Kewaunee / Point Beach Nuclear  
Operated by Nuclear Management Company, LLC

Dockets 50-266 and 50-301  
Point Beach Nuclear Plant, Units 1 and 2  
License Amendment Request 224  
Control Room Habitability

**DESCRIPTION AND ASSESSMENT OF CHANGES**

**POINT BEACH NUCLEAR PLANT, UNITS 1 AND 2**

Figure 6.2-4: CR HVAC Emergency Mode with Phase 2 Modifications Complete

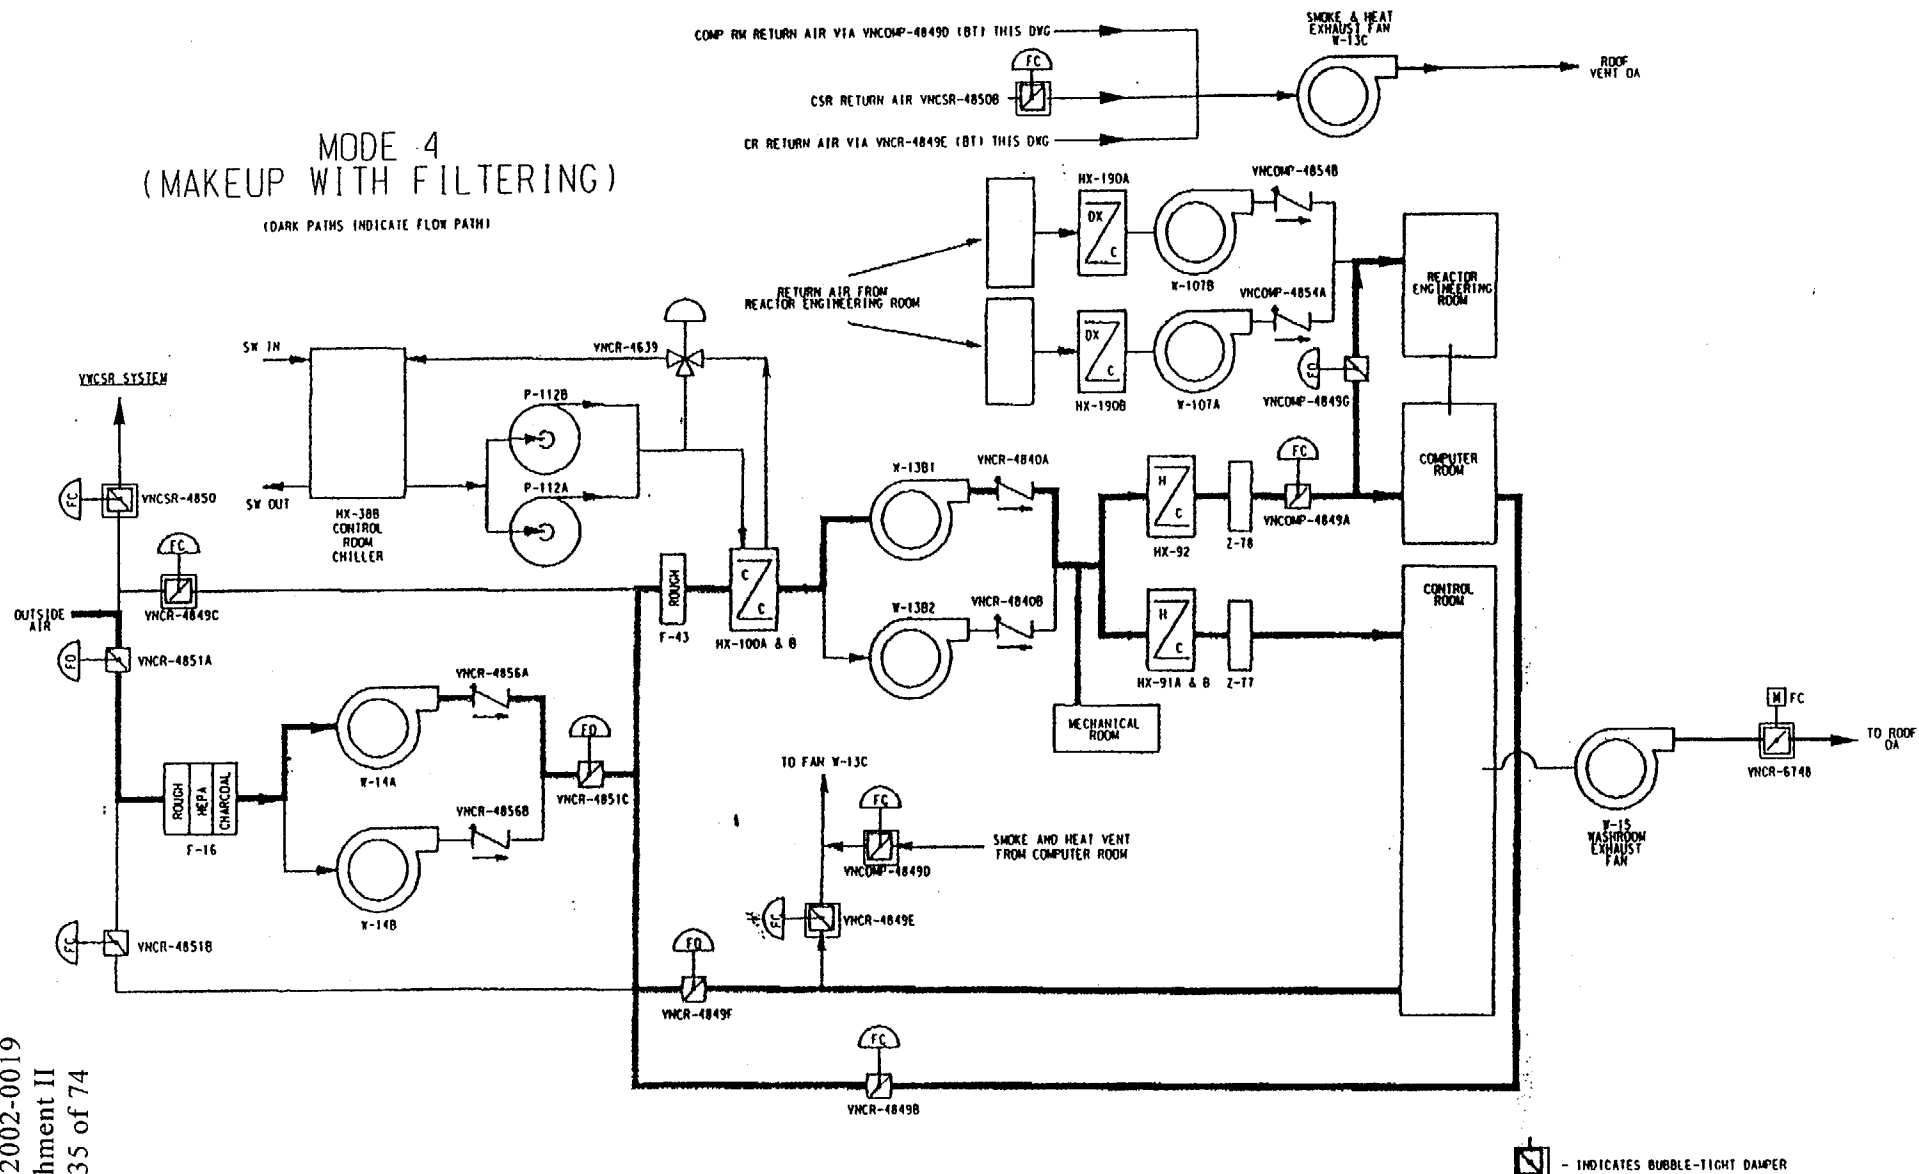
The CR HVAC actuation logic will be modified such that a containment isolation signal will place the control room ventilation system directly in emergency mode of operation (Mode 4), thereby, reducing the delay time for actuation. This modification will help reduce the dose to the operator for accidents that historically had relied on the RMS high radiation setpoint to switch the operating mode of the CR HVAC.

Future Configuration, after Phase 2 Damper Modification  
(Pending NRC Approval of AOT Extension)

Figure 3.4.16-1 (page 1 of 1)  
Reactor Coolant DOSE EQUIVALENT I-131 Specific Activity  
Limit Versus Percent of RATED THERMAL POWER

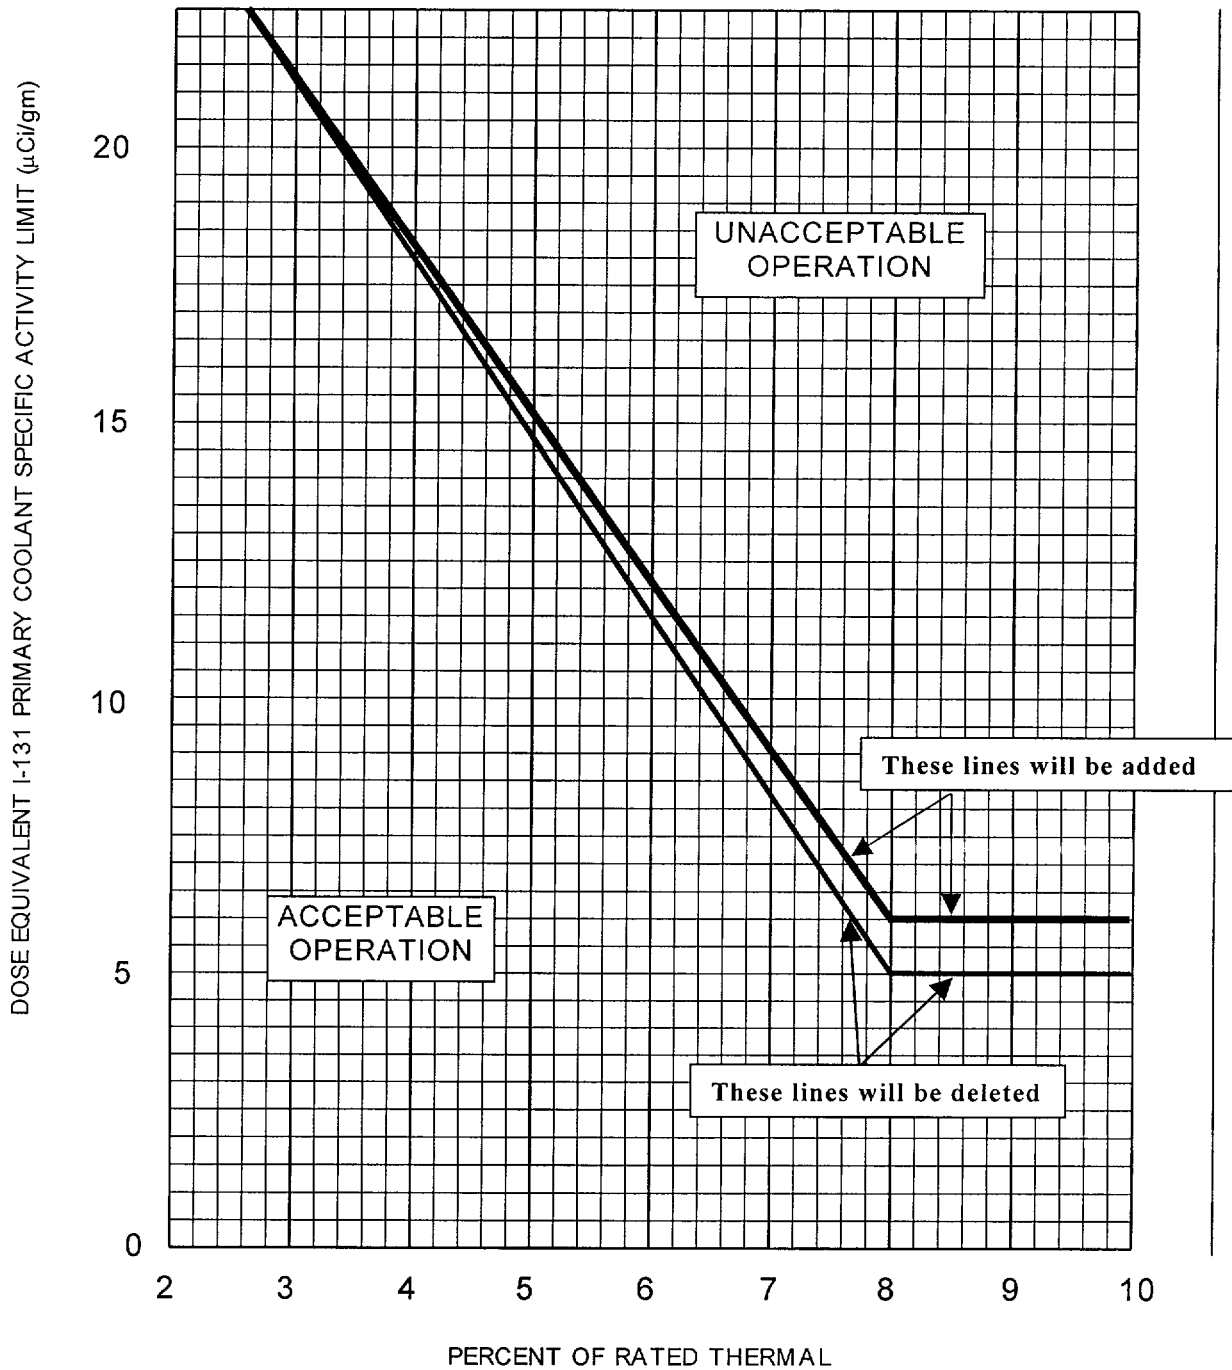
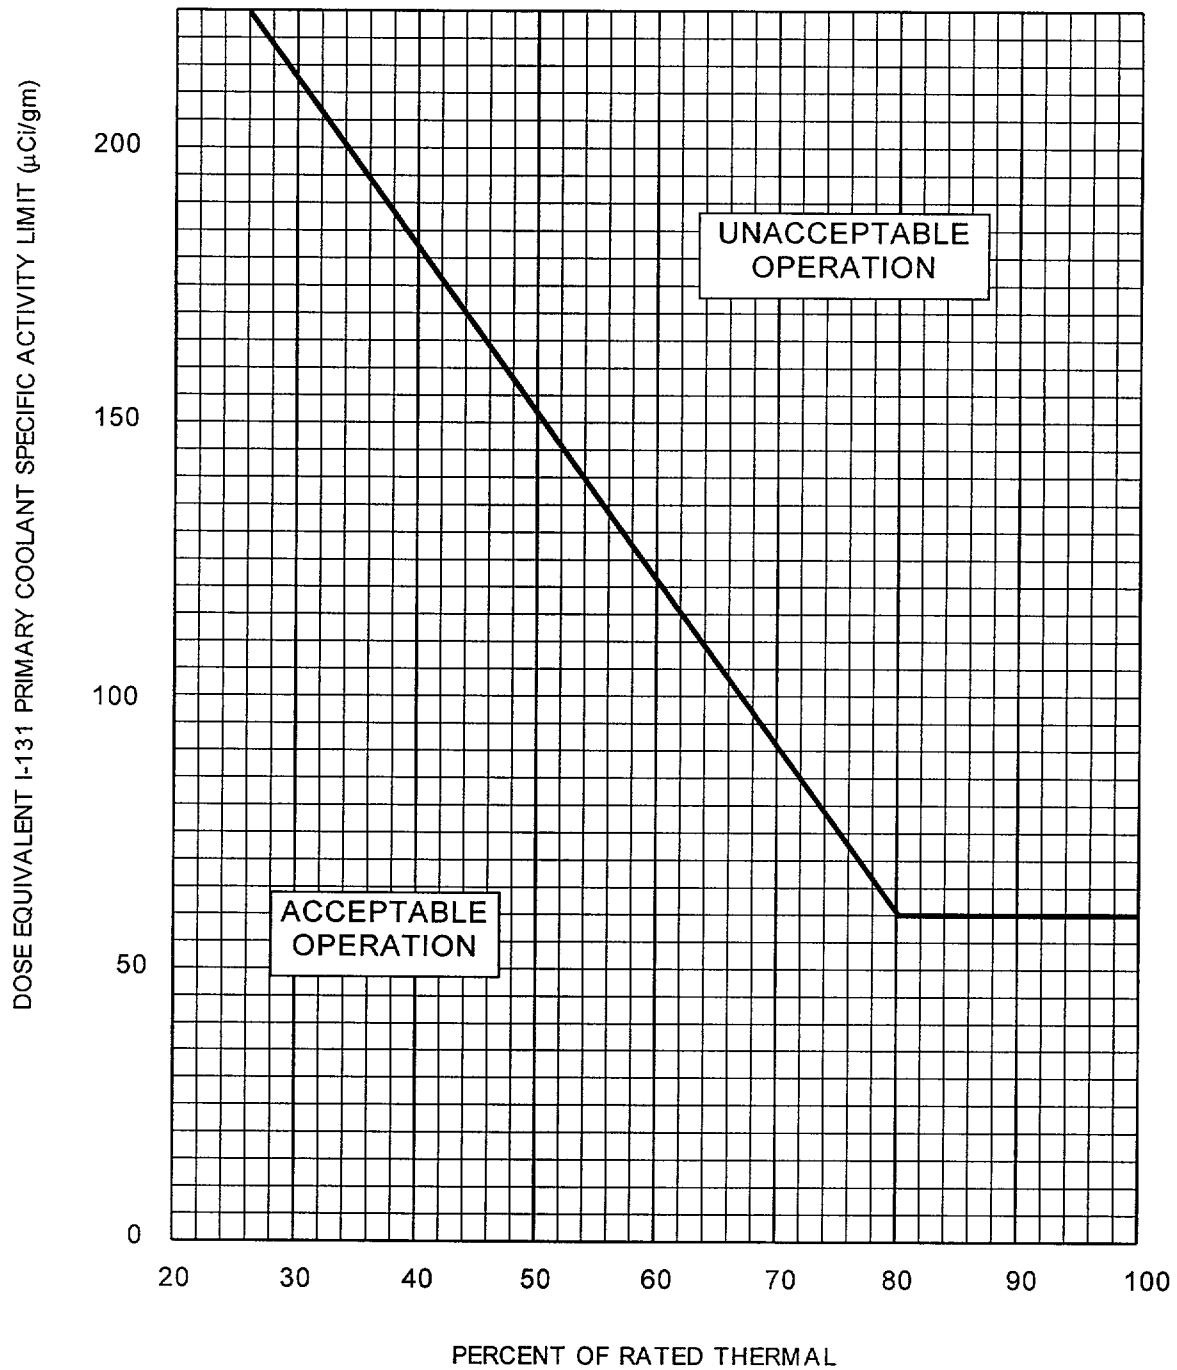
- b. Action Condition C references Figure 3.4.16-1, "Reactor Coolant Dose Equivalent I-131 Specific Activity Limit versus Percent of Rated Thermal Power." This figure will be revised to indicate 60  $\mu$ Ci/gm DE I-131 as the maximum RCS limit for operations at or above 80% of rated thermal power.
